1957 - 1962 Corvette: Chevrolet Advance Information: New Clutch Pressure Plate Released for 1962 Corvette

Subject: New Clutch Pressure Plate Released for 1962 Corvette

Model and Year: 1957 - 1962 Corvette

Bulletin No: A.I. #62-3

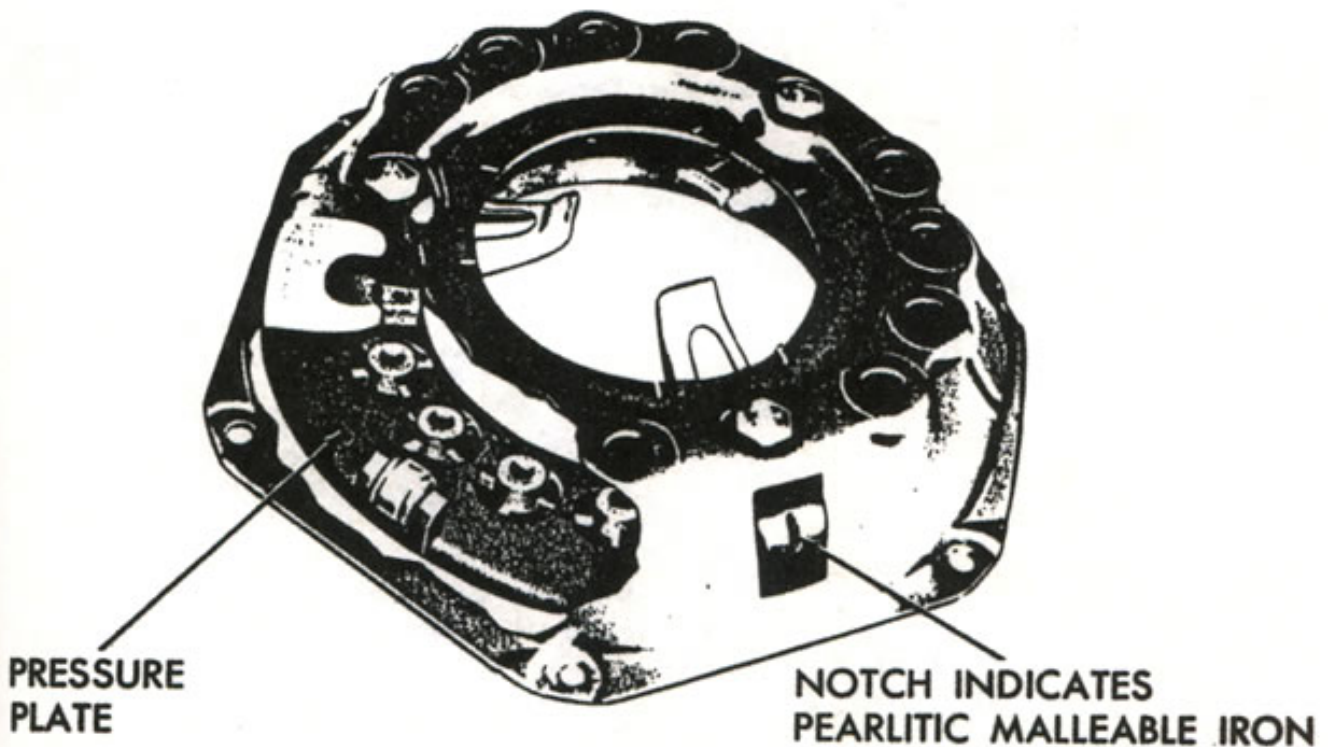
Due to the increased frequency of clutch failures on 1961 High-Performance Corvettes, Engineering has released a new clutch pressure plate made of pearlitic malleable iron in place of the previously used grey cast iron. This new material will provide improved resistance to failure at high RPM's for all mechanical tappet equipped 1962 Corvettes.

The pearlitic malleable iron pressure plate may be identified by a cast depression in each driving lug as shown in Figure 1.

The new pressure plate and the clutch cover-pressure plate assembly are interchangeable with past models from 1957-61. They will be used for service replacement on all 1961 High Performance (RPO 354 and 468) Corvettes as soon as parts are available, and will eventually service all 1957-61 models when present stock of 1961 material is exhausted.
